Christofferson Ranch

Development Agreement

Staff Comments

1.1 Subdivision Layout

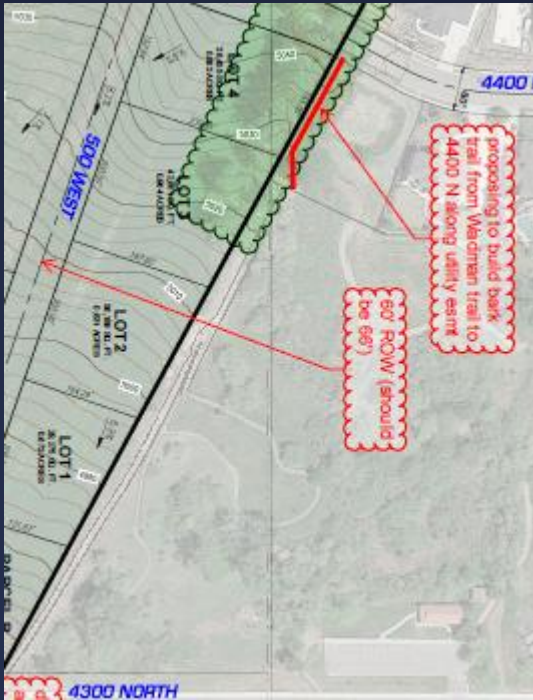
Lot sizes do not include road rights-of-way. If subdivision remains A-2 (without cluster), maximum number of lots would be 11.

- 18.35.040 Cluster Developments contains no allowances for bonus density.

Maximum number of lots shall be calculated as: the overall Property area of 26.33 acres *minus all road rights-of-way and detention pond parcel area*, divided by 2 acres. Maximum number of lots would be 13.

1.2 Roadways

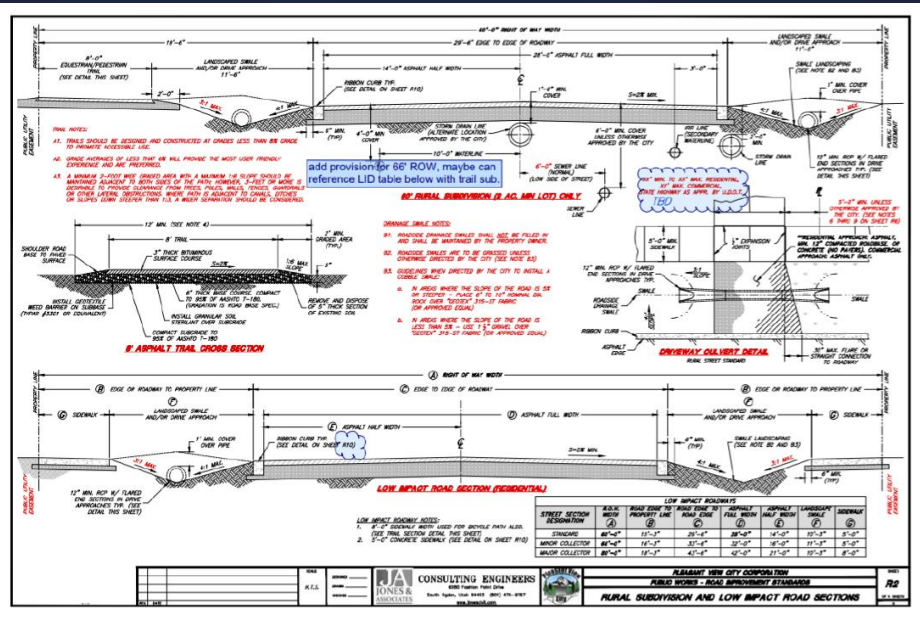
Developer is required by City ordinance §17.18.010.2 to incorporate elements of City's Master Street Plan into the development design.

Second sentence of developer's item i (specifically, 8' wide sidewalk) does not match to existing or conform to proposed improvements along 4300 North.

- i. Dedicate the necessary 4300 North right-of-way as requisite per the adopted Master Street Plan during the subdivision process.

- li. Design and construct any necessary improvements as designated by the City's *Development, Design, and Construction Standards*. ~~This would include an 8' wide sidewalk, curb and gutter, and asphalt extension from front of curb to existing asphalt on 4300 North to the western boundary of the property line.~~

1.2 Roadways

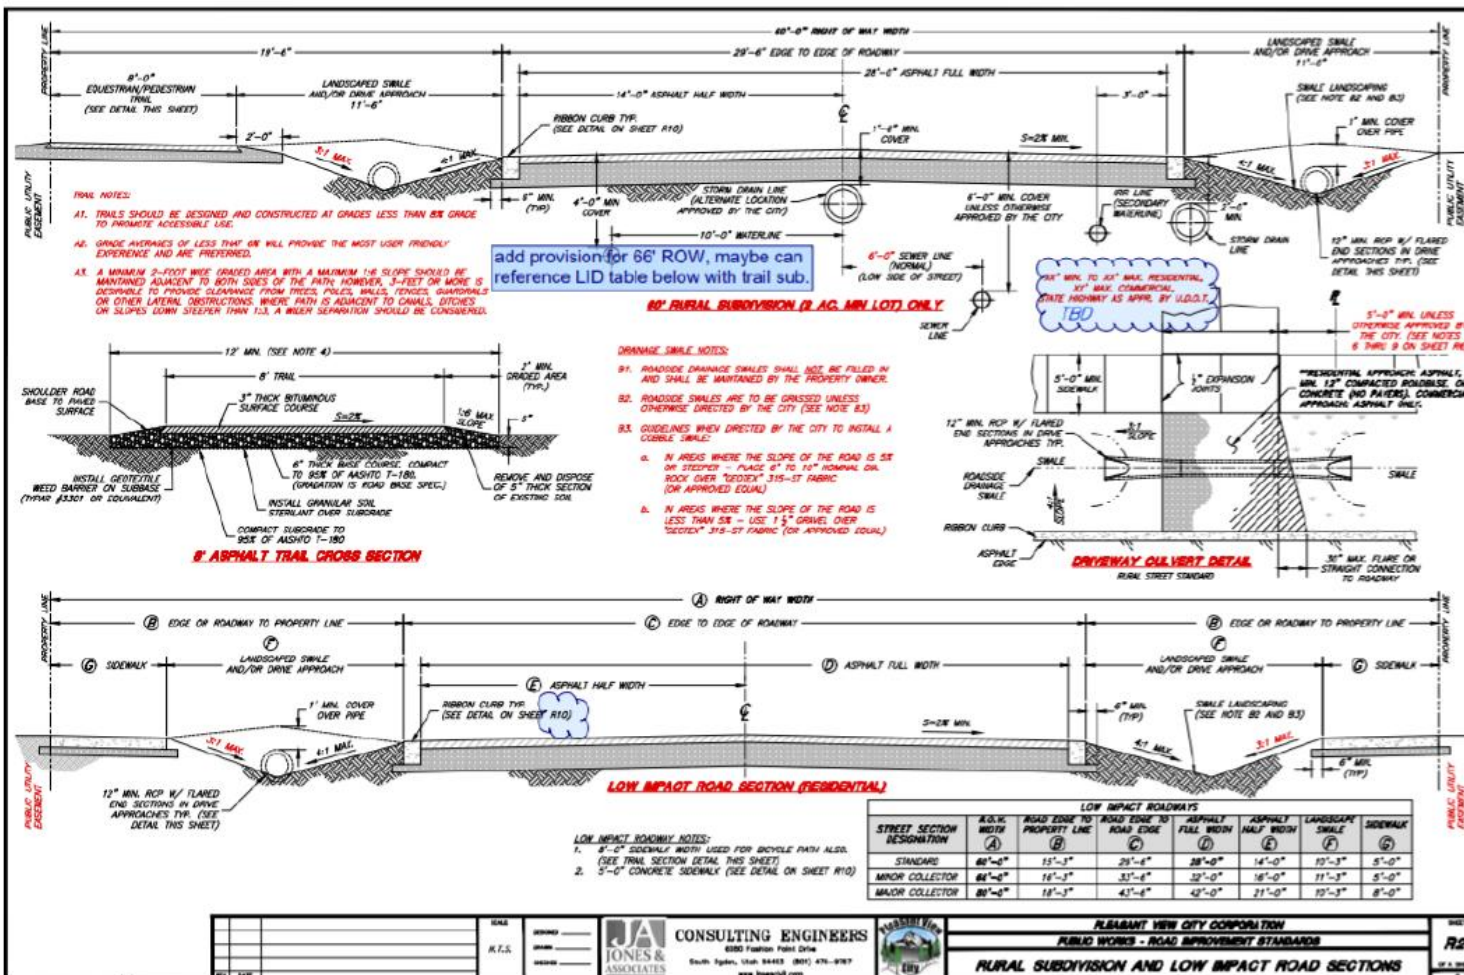
Developer's width of 500 West does not conform to the City's Master Street Plan; therefore, it is in violation of City ordinance §17.18.010.

Staff recommends not including subparagraphs a and b as this detail is provided in proposed Exhibit C.

Staff recommends installation of the trail the full length of 500 West, from 4300 North to 4575 North; the width of the trail to be wider than a standard sidewalk, as it is intended to be a multi-use trail and there is only trail on one side of the road. Subparagraph iii may be struck out entirely as the trail standards are contained in the exhibit.

a. Dedicate a 66-foot wide right-of-way extending from 4300 North Road to 4575 North Road.

b. Design and construct a 66-foot wide rural roadway as detailed in Exhibit C.

c. Trail Requirements: An asphalt trail shall be constructed on the west side of 500 West from 4300 North to 4575 West within the right of way road dedication. The trail shall have a minimum width of eight (8) feet, including appropriate curb ramps at intersections and designated pedestrian crossings.

1.2 Roadways

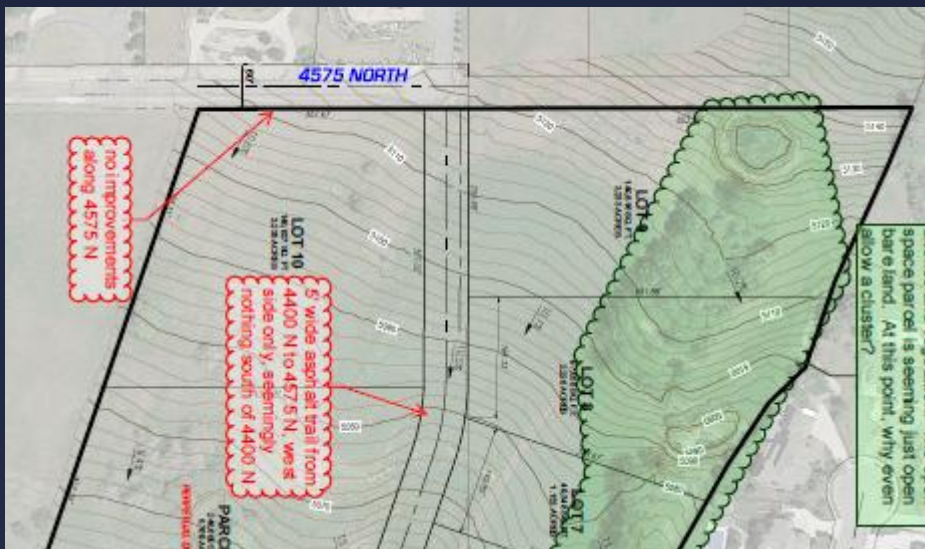
Staff recommends that the 4400 West right-of-way extend to the western boundary of the subdivision in accordance with City ordinance §17.18.010: "...make provisions for the continuation of the existing streets in adjoining areas (or their proper protection where adjoining land is not subdivided...)"

At the Council's discretion, construction of 4400 North west of 500 West could be omitted.

i. Dedicate a 60-feet wide right-of-way extending from its current terminus westwards to *the west boundary of the subdivision*.

ii. Design and construct 60-foot-wide road to match existing road on 4400 North, *from its current terminus to 500 West*.

1.4 – Special Subdivision Requirements

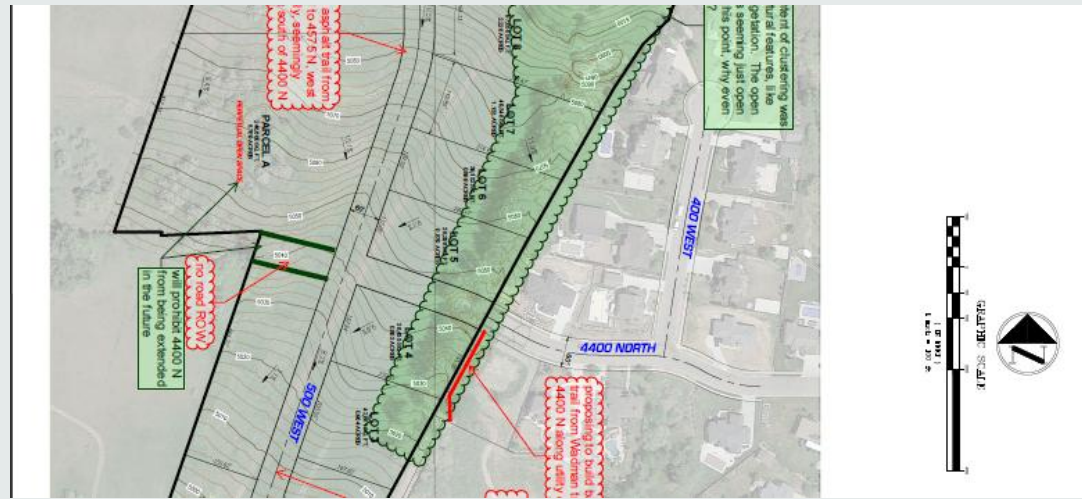
- Regarding subparagraph a.ii – Ordinance §18.35.040 G states that open space shall be preserved for “recreation and/or open space”; no provisions for agricultural, education, or building purposes are listed in the ordinance.
- Regarding paragraph c – City has not yet confirmed with Pineview Water System the irrigation requirements/restrictions. Subparagraph iv is not binding via this development agreement.

i. Developer shall preserve Parcel A as a perpetual open space in accordance with §18.35.040.G. Perpetual preservation will be accomplished by recording the Dedication Agreement with Weber County as outlined in Attachment D on the final plat.

ii. The Developer shall be responsible for maintaining Parcel A as nature scape for wildlife preservation, agricultural, educational, and recreational purposes. Specific maintenance obligations include but are not limited to fertilization, mowing, fence maintenance and outbuilding maintenance if applicable.

b. Wetlands, as shown in *Aquatic Resources Delineation Christofferson Farm Pleasant View, Utah, May 2022*, prepared by Wetland Resources (Logan, Utah), on file with the City, shall be *protected with easements* shown on the subdivision plat.
